# APPENDIX F

## RUNWAY SAFETY ACTION PLAN

**Charles M. Schulz/Sonoma County Airport  
Runway Safety Action Plan  
March 24, 2010**

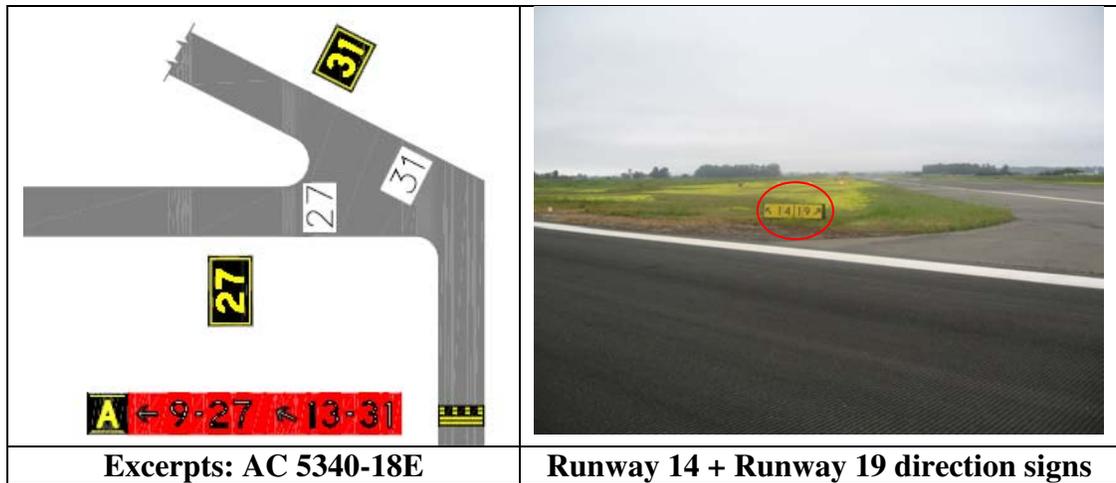
- 1) Taxiway Z, while marked, is not identified by aboveground signage and may benefit from either aboveground or surface painted signs. Alternatively, parallel ramp Taxiway Z may be eliminated completely west of Taxiway Y (see STS-2010-003 below).

- 2) Suggest the installation of Runway 14 and Runway 19 destination signs, to be installed on Taxiway Y and just south of the intersection of Taxiway A, visible to pilots taxiing north on Taxiway Y, as well as on Taxiway A, just east of the intersection of Taxiway Y, visible to pilots taxiing west on Taxiway A.

- 3) Recommend that Taxiway Y be more clearly identified with aboveground signage. The RSAT Team noted the fronts and the backs of four “VSTR” signs along Taxiway Y that could be utilized to provide location or directional information (see pictures below). Taxiway Y is predominantly marked by exit signs that are typically difficult for pilots to read.

- 4) A combination of direction and location signs, elevated and surface painted, should be installed to guide pilots operating on Taxiways C, Y, and Z, near the intersection of those taxiways, since no signage is currently available in this area. Additionally, taxiway identifiers on the hangar rows near this area may assist pilots and ATC when giving location or destination information.

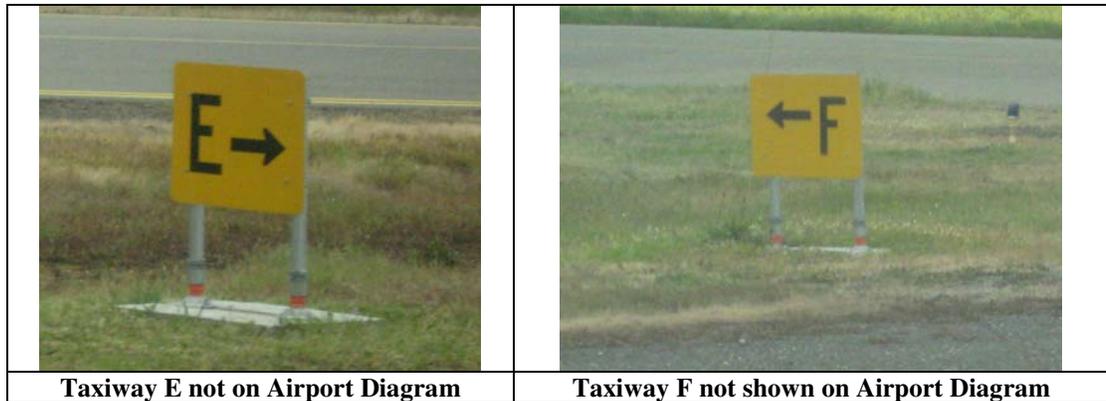
- 7) A black on yellow direction sign at the apex of Runway 14 and Runway 19 (photo below) may be inappropriate or non-standard due to its location in the Runway Safety Area (RSA), with the absence of any mandatory sign for Runway 1/19. Recommend the airport review the sign type, placement, and location with its Certification Safety Inspector. The RSAT Team recommends that the airport request to have its sign plan reviewed and approved for its ACM, with the photo

below (left) providing an example of standard signage for this area. Please note the runway location signs, which the RSAT Team feels are crucial for the prevention of wrong-runway departures.

- 8) An area in the AOA marked with a white-on-red “No entry” sign appears to be permanently closed on Taxiway W. Entry from the west side of Runway 1/19 is blocked via orange cones (see pictures below). However, this abandoned area has a Mandatory Runway Holding Position Sign and associated Hold Position Line marking. The markings and signage may partially imply that the area is taxiway available for aircraft use. The airport should consult its Certification Safety Inspector for appropriate signage and marking of this area to prevent any confusion about its availability for normal aircraft use. This may include removing the Runway Holding Position Sign and hold bar markings.

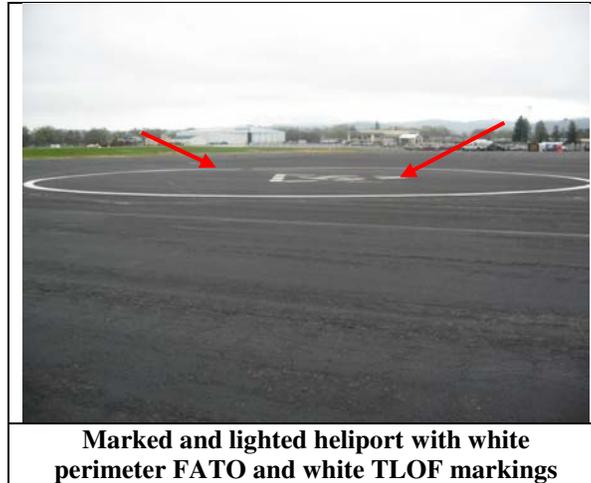
**Observation:** It was noted that a lighted and marked heliport on the airport apron near the intersection of Taxiway Z and Taxiway B is not listed in the Airport Master Record (5010) and has been marked with a white FATO (see picture below). Also noted adjacent to the heliport were several improved helicopter parking pads. The RSAT Team was unable to locate a record or finding related to an airspace determination or established traffic pattern, including approach and departure paths associated with this facility. In this instance, heliport incursions and/or surface incidents may occur where fixed-wing or rotor aircraft simply pass through the white marked area without ATC clearance. The risk to helicopter pilots at night, when the tower is closed, is that they may incorrectly assume that adequate protection from incursions is provided by virtue of the facility’s layout alone.

**Action Item:** The RSAT Team recommends that the airport file FAA Form 7480-1 to formally establish the aeronautical facility (heliport) located near the intersection of Taxiway Z and Taxiway B. The heliport should also be included in the Airport Facility Directory and 5010. Heliports provide at a minimum clear 8:1 approach and departure surfaces, with those imaginary surfaces normally depicted on the ALP. Additionally, the RSAT Team recommends that heliports on airports be located in non-movement areas so the normal ingress and egress of passengers may occur without escort. Finally, properly establishing this new aeronautical facility may require both NEPA and CEQA. Alternatively, the airport may choose to establish a helicopter parking area in place of the current heliport. Helicopter parking facilities are normally marked with yellow perimeters and do not require airspace or approach/departure surfaces. In addition, while heliport lighting is amber, helicopter parking areas have their perimeters delineated with blue lights.
